Access Compliance Report Public Rights-of-Way (Curb Ramps)

Intersection ID: 30481 Main Street: PLOWSTONE_CT Cross Street: WALKING_STICK_DR Location: S

ADA ID: EE1C8AC097AD Ramp Type: PerpDiag Initial Pass/Fail: Fail Overall Compliance: No Severity Score: 37.5

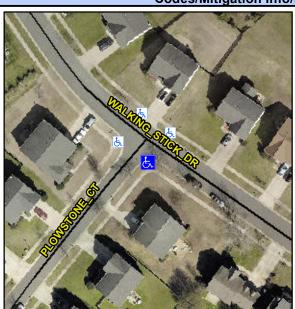
R304.2.2, R304.5.3

Compliance Description		Data	Compliance Description		Data	
N/A	Ramp Length (in)	83.0	No	Ramp Slope (%)	8.6	
Yes	Ramp Width (in)	92.0	No	Ramp XSlope (%)	8.2	
N/A	Flare Type LT	N/A	N/A	Flare Type RT	N/A	
N/A	Flare Slope LT (%)	N/A	N/A	Flare Slope RT (%)	N/A	
N/A	Flare Traversable LT?	N/A	N/A	Flare Traversable RT?	N/A	
N/A	Landing Length (in)	N/A	N/A	DWS Provided?	N/A	
N/A	Landing Width (in)	N/A	N/A	DWS Contrast?	N/A	
N/A	Landing Slope (%)	N/A	N/A	DWS Length (in)	N/A	
N/A	Landing X Slope (%)	N/A	N/A	DWS Full Width?	N/A	
N/A	Landing Curb? (Y/N)	N/A	N/A	DWS Offset (in)	N/A	
N/A	Shared Landing?	N/A				
N/A	Gutter Ponding?	N/A	N/A	Gutter Slope (%)	N/A	
N/A	Gutter Lip Ht (in)	N/A	N/A	Gutter X Slope (%)	N/A	
N/A	Painted X Walk1?	No	N/A	Painted X Walk2?	No	
	X Walk 1 Direction	To NE		X Walk 2 Direction	To NW	
N/A	X Walk 1 Width (in)	N/A	N/A	X Walk 2 Width (in)	N/A	
	X Walk 1 Slope (%)	6.0		X Walk 2 Slope (%)	1.6	
	X Walk 1 X Slope (%)	2.6		X Walk 2 X Slope (%)	6.2

Remove & Replace Curb Ramp With Two New Directional Ramps or Equivalent.
